**ADDENDUM
NO. 4**

October 18, 2024

**Whiteland High School Ph 2: Café Kitchen Band Choir Auditorium
300 E. Main Street
Whiteland, IN 46184**

ROOF DETAILS

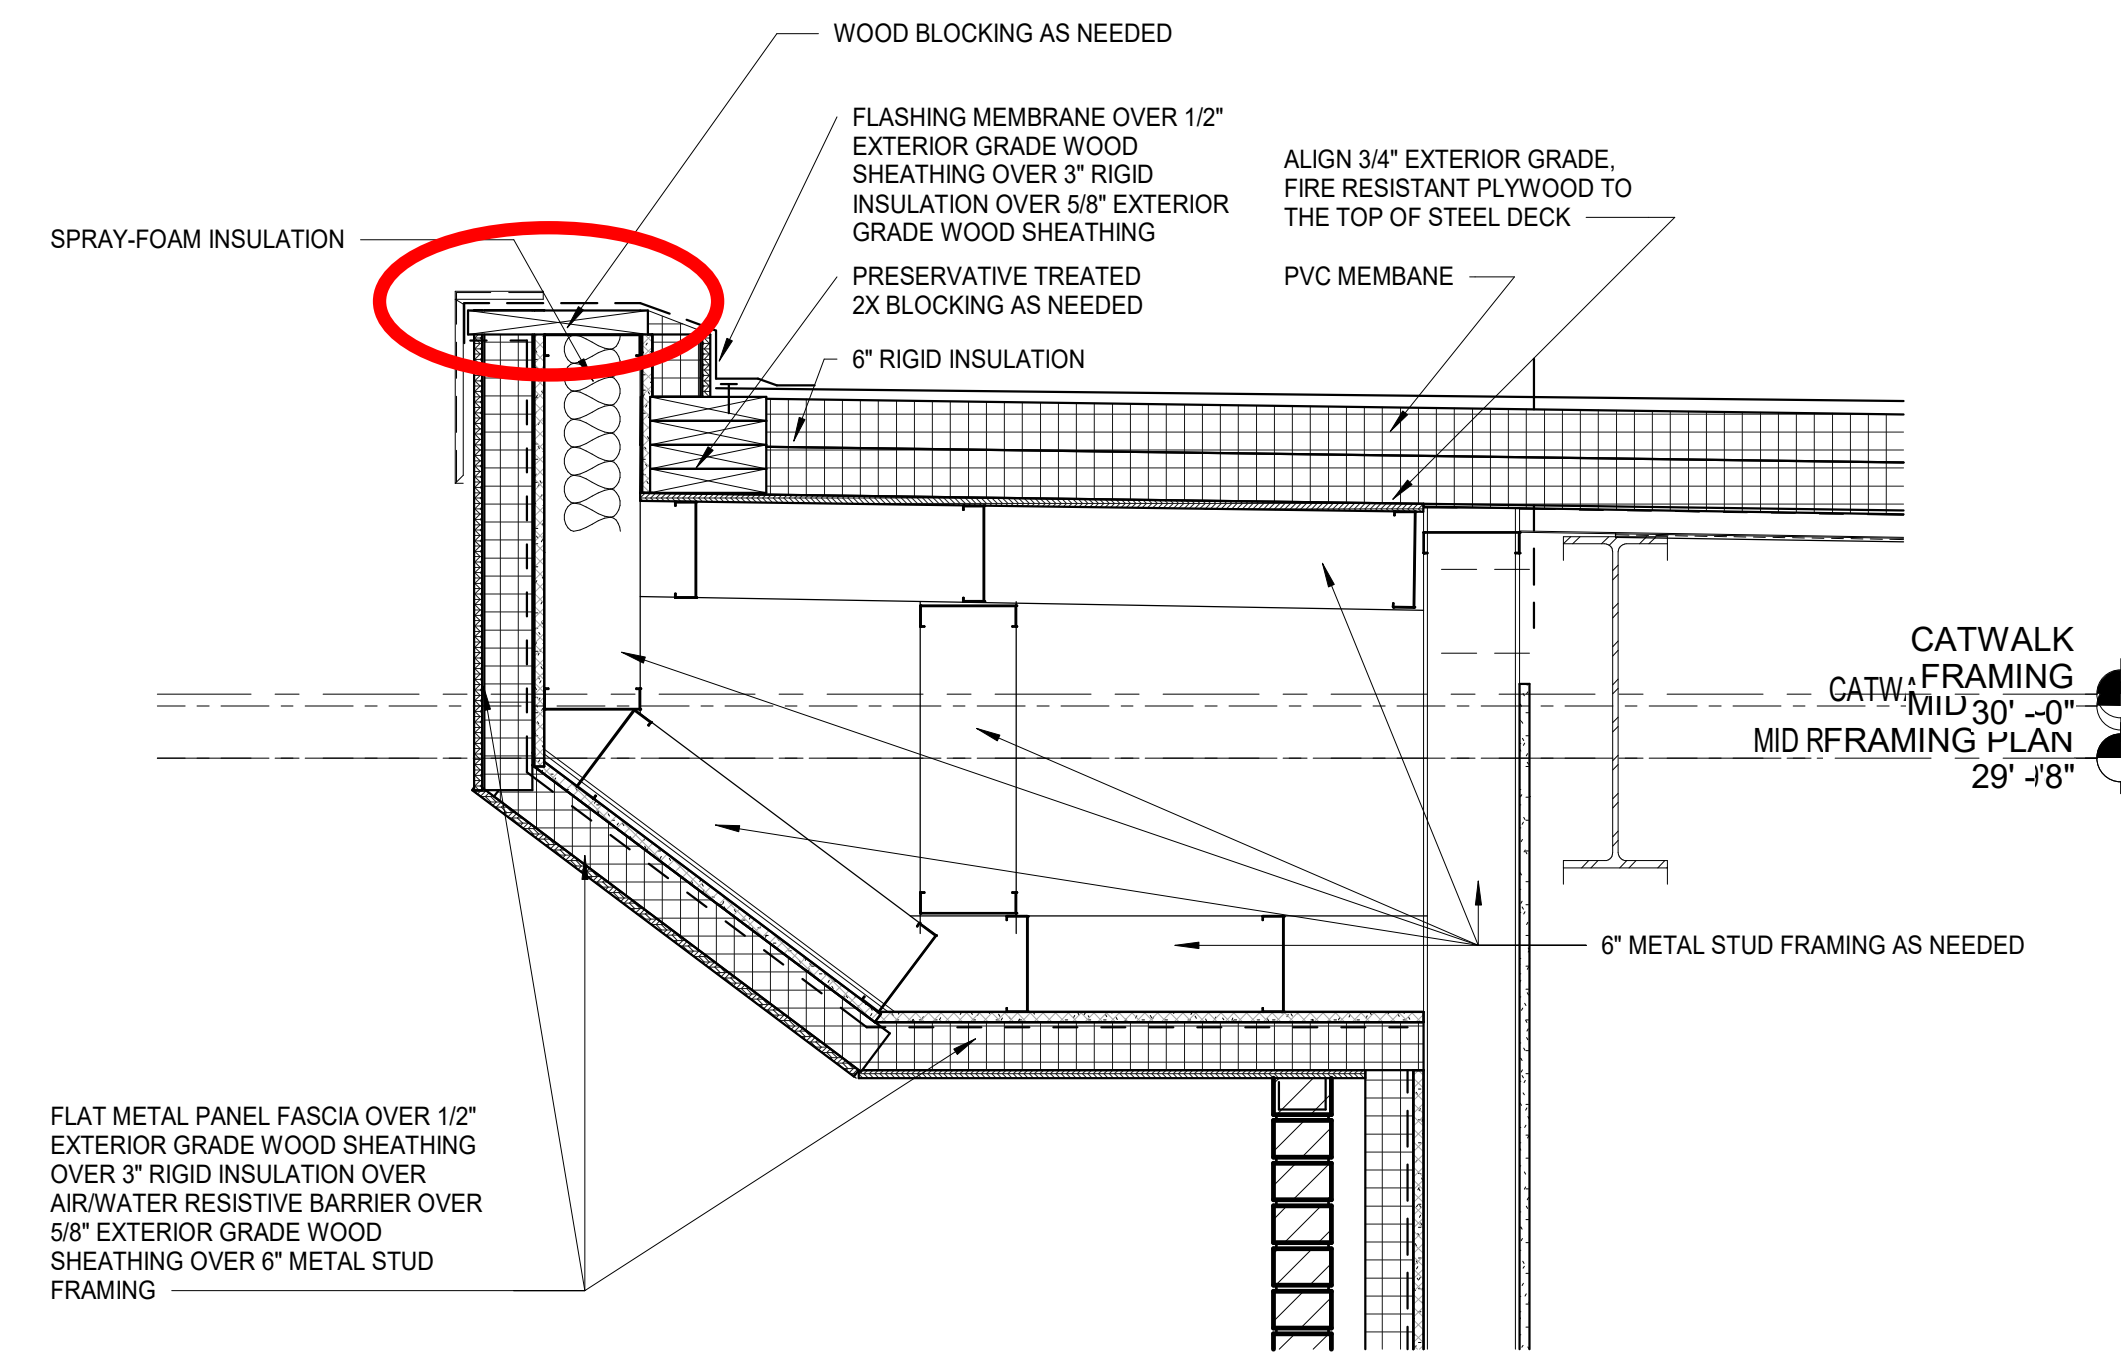
7. Bid Category No. 5 – Metal Studs, Drywall, and Acoustical Contractor is responsible for any board insulation behind metal panels that include Z-Girt installation.
8. Bid Category No. 5 – Metal Studs, Drywall, and Acoustical Contractor is responsible to provide and install all required wood blocking circled in red in the attached

all blocking in question and circled in red will be the responsibility of Bid Category No. 5 Contractor
